DRAFT IV

NATIONAL PARKS AND NATURE CONSERVATION AUTHORITY

SUBMISSION ON THE HILL RIVER COAL MINE

AND POWER STATION PROJECT

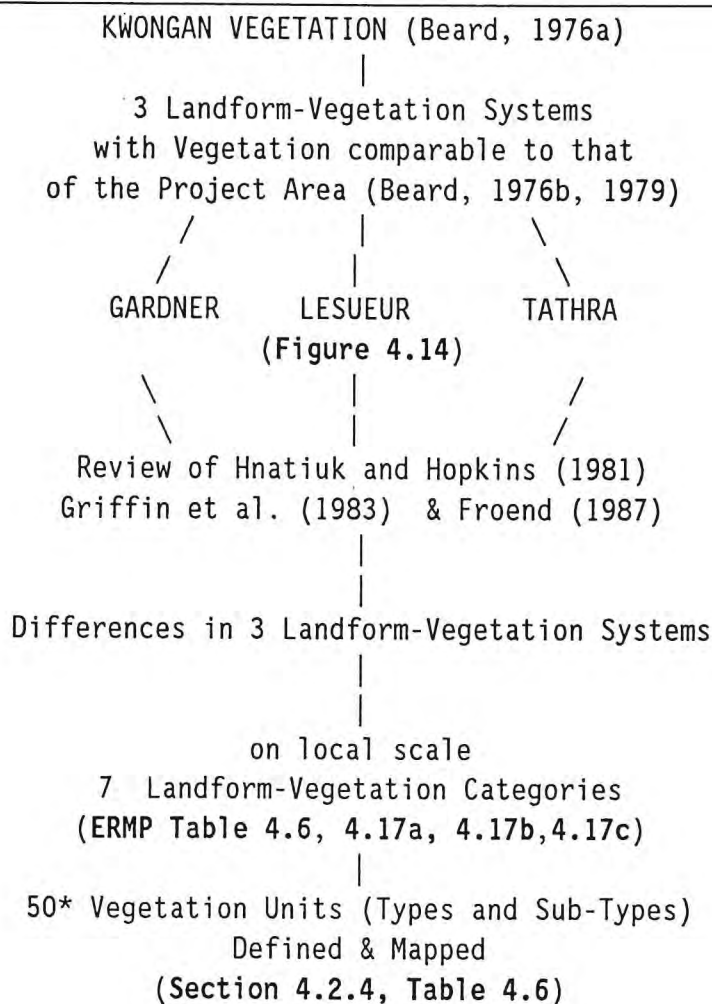
In the summary of the existing environment (page iii) the statement "It has been concluded that the most common vegetation types in the Project area are also widely distributed in the region" does not reflect the obvious complexity of the results collected regarding the vegetation. For example:-

- . The potential impact of the development on the vegetation is evident from a review of the location of the project area in relation to the Geology (Section 4.1.2 and Figures 4.2 & 4.3), the Topography and Geomorphology (Section 4.1.3, Figure 4.7), the Soils (Section 4.1.4, Figure 4.8), the Hydrogeology (4.1.5) the Surface Hydrology (Section 4.1.6, Figure 4.11 and 4.12) each of which illustrates the extreme background complexity of the Lesueur area. The proposed project spans the boundaries of diverse underlying elements and superficially overlaps a range of soils and catchment areas which is recognized as being critical in the complex delineation of the vegetation of the area.

- . (page v) of the document states that the "clearing will take place within one Vegetation System (the Gairdner System), and 1,850ha represents 4.6% of the Gairdner System in the Hill River area". No direct reference is made to the degree of clearing which has already taken place within the Gairdner Vegetation System nor the fact that this project extends into the Lesueur Vegetation System (Figure 4.14).
